TO: City of Peoria Zoning Commission
THRU: Site Plan Review Board
FROM: Kimberly Smith, AICP, Senior Urban Planner
DATE: July 2, 2009

SUBJECT: PUBLIC HEARING ON THE REQUEST OF SHAWN LUESSE, AGENT FOR ELDORADO PARTNERS, OXBOW DEVELOPMENT CORPORATION TO OBTAIN A SPECIAL USE IN A CLASS WM (WEST MAIN FORM) DISTRICT FOR VARIANCES TO ALLOW FOR THE DEVELOPMENT OF A RESIDENTIAL/COMMERCIAL PROJECT FOR THE PROPERTIES IDENTIFIED AS PARCEL IDENTIFICATION NOS. 18-05-406-004, 18-05-406-005, 18-05-406-006, 18-05-406-008, 18-05-406-009, 18-05-406-010, 18-05-406-011, 18-05-406-014, 18-05-407-004, AND 18-05-407-005, AND WITH ADDRESSES OF 1014, 1016, 1021, 1023, AND 1027 N. BOURLAND AVENUE, 1014, 1016, AND 1018 N. UNDERHILL STREET, AND 1109 W. MAIN STREET, PEORIA, ILLINOIS. VARIANCES ARE REQUESTED FROM THE REQUIREMENTS OF BUILDING ENVELOPE STANDARDS AND ARCHITECTURAL STANDARDS TO INCLUDE BUILDING STREET-SPACE ENTRIES, STREET WALLS, REQUIRED BUILDING LINE FRONTAGE, STREET FACADES, BUILDABLE AND OPEN AREAS, FRONTAGE WIDTHS, WINDOWS, AND ENTRIES. CASE NO. ZC 09-18B (COUNCIL DISTRICT 2)

RE: Main Street Commons

SITE PLAN WITH OPEN SPACE

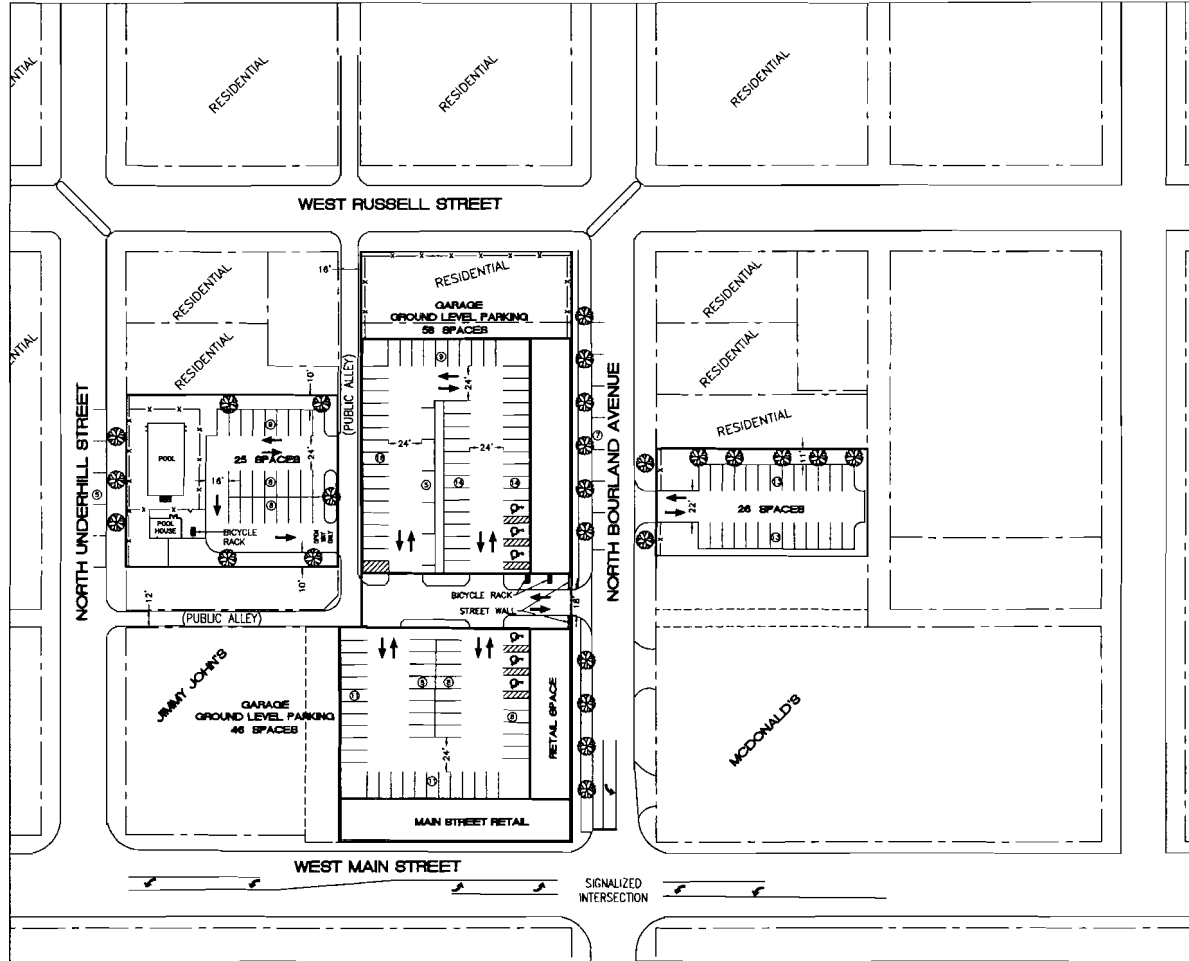
4. Section 6.4.E.9.b: West Main – Local, Buildable Area. This section requires a contiguous open area equal to 20% of the total buildable area. We are asking a variation for the contiguous requirement and believe a text amendment is being processed in regards to this section as well.

1 Copy of N East Elevation
1" = 20'-0"

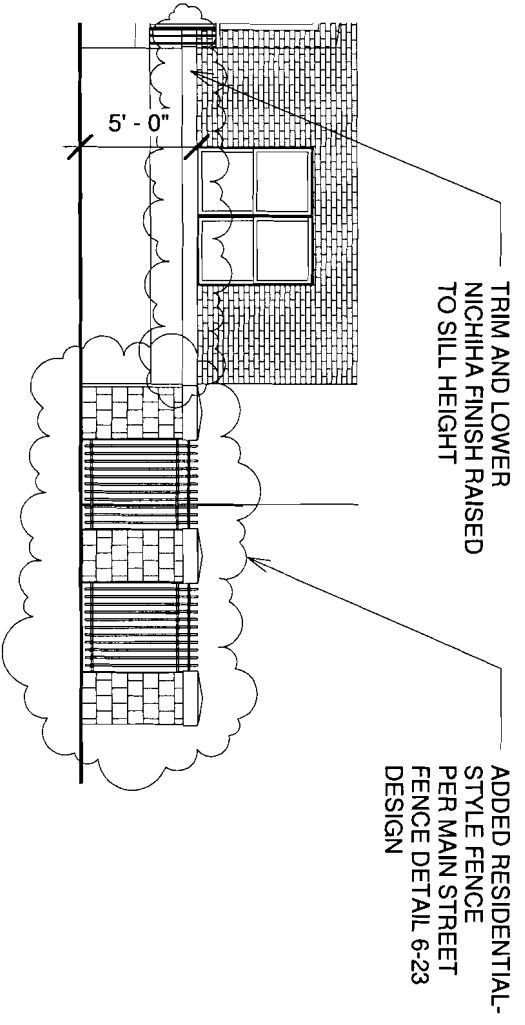
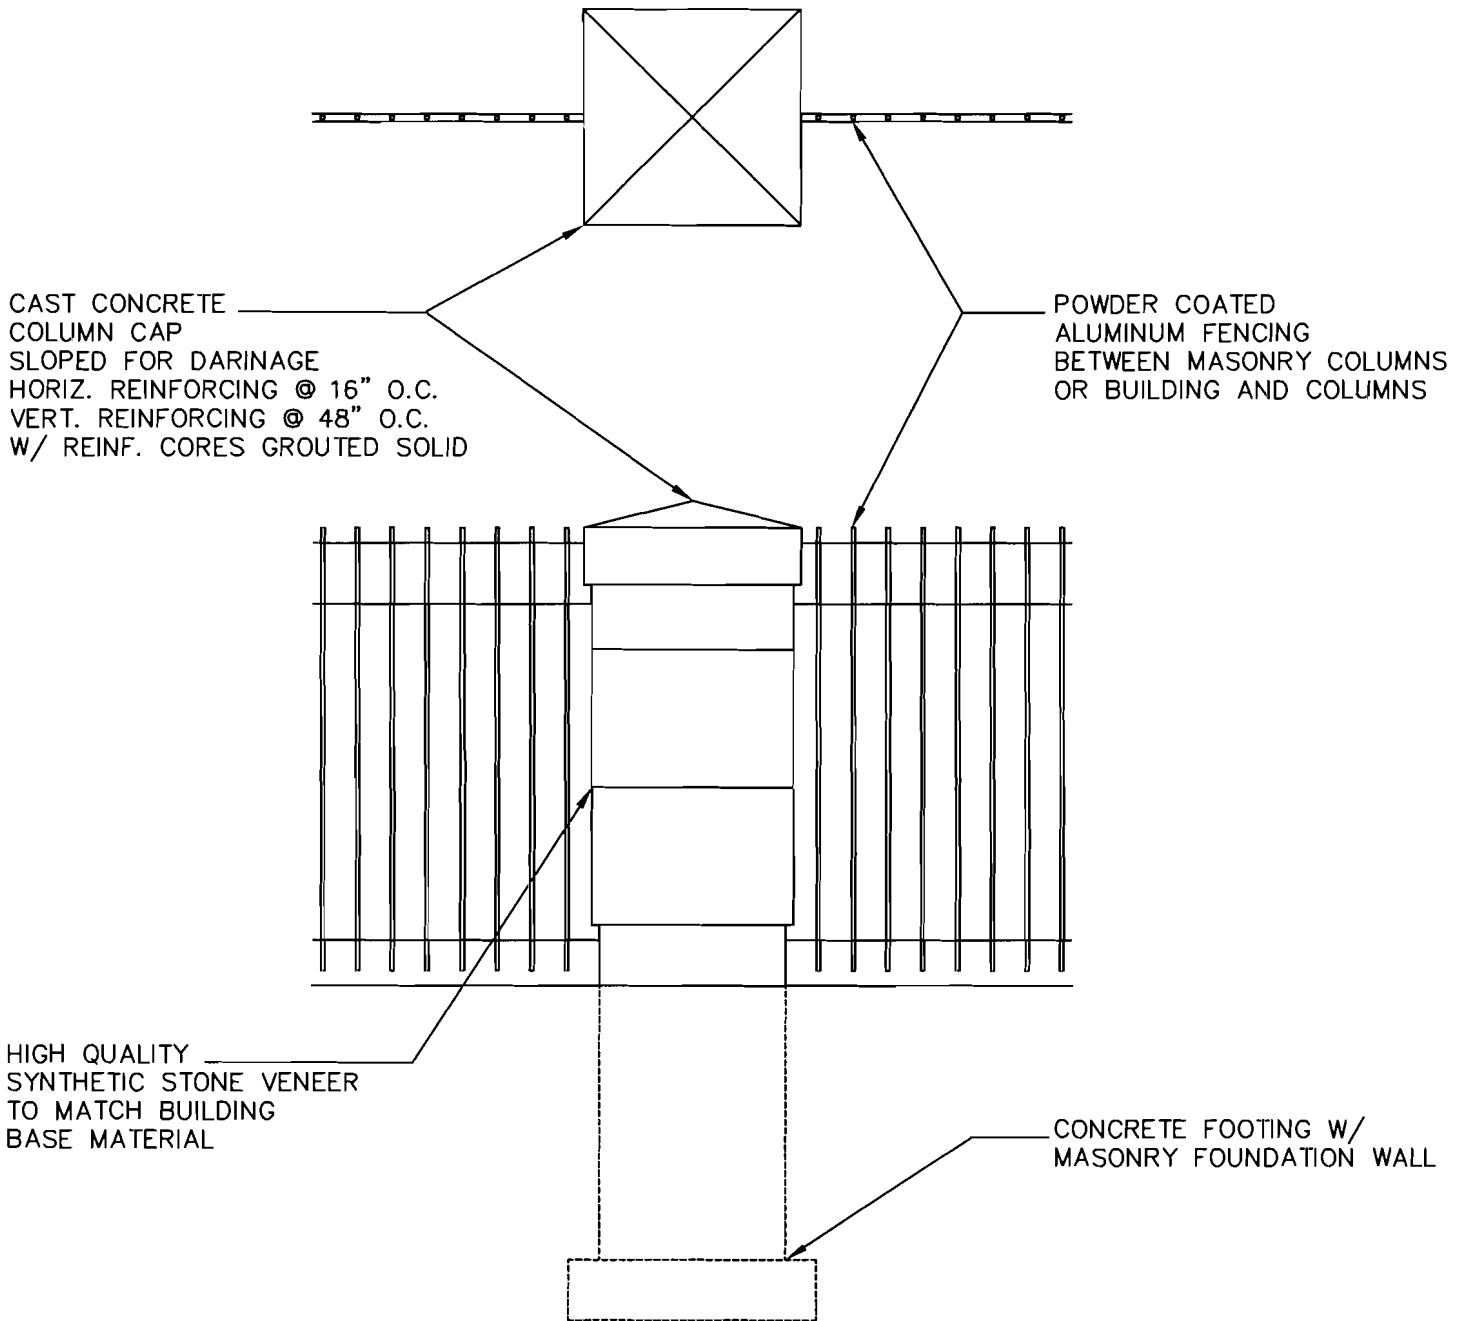
REGULATION	COMMENT
1	<u>Section 6.1.6.B.2.: Form Districts, New Development, Buildings.</u> Each façade composition shall include a functioning, primary, street-space entry.	Requested to allow stairs to serve specific units, as proposed, along Bourland in the Local Frontage (see attached elevations).
2	<u>Section 6.4.E.6.: West Main - Local, Street Wall and Fence Height.</u> A street wall not less than 4 feet or greater than 8 feet in height shall be required along any required building line that is not otherwise occupied by a building.	Requested to allow an alternative that establishes a division between the public and private space, such as a fence with masonry pillars. The regulation as stated would require a wall four to eight feet that would extend to the residential, R4 frontage.
3	<u>Section 6.4.E.8.a.: West Main - Local, Siting, Street Facade.</u> Build building facade to required building line for at least 70% of the required building line.	Requested to allow portions of the proposed building façade to intermittently meet 70% of the required building line.

Separation between facades (as opposed to the building) does not meet this requirement.
4	Section 6.4.F.4.c. West Main –Local, Elements, Doors/Entries. Each lot shall have a functioning entry door on the required building line façade.	Requested to allow for the entry doors along the east elevation to set recessed behind the balcony/porch as is encouraged in Section 6.4.4.B.6.

9. Section 6.4.F.4.c West Main – Local, Elements, Doors/Entries. This section requires each lot to have a functioning entry door on the required building façade. We do have functioning doors set behind a balcony/porch along this line. We would like to request a variation to allow for the doors to set recessed behind the balcony/porch as is encourage in Section 6.6.4.B.6 and as we have designed.
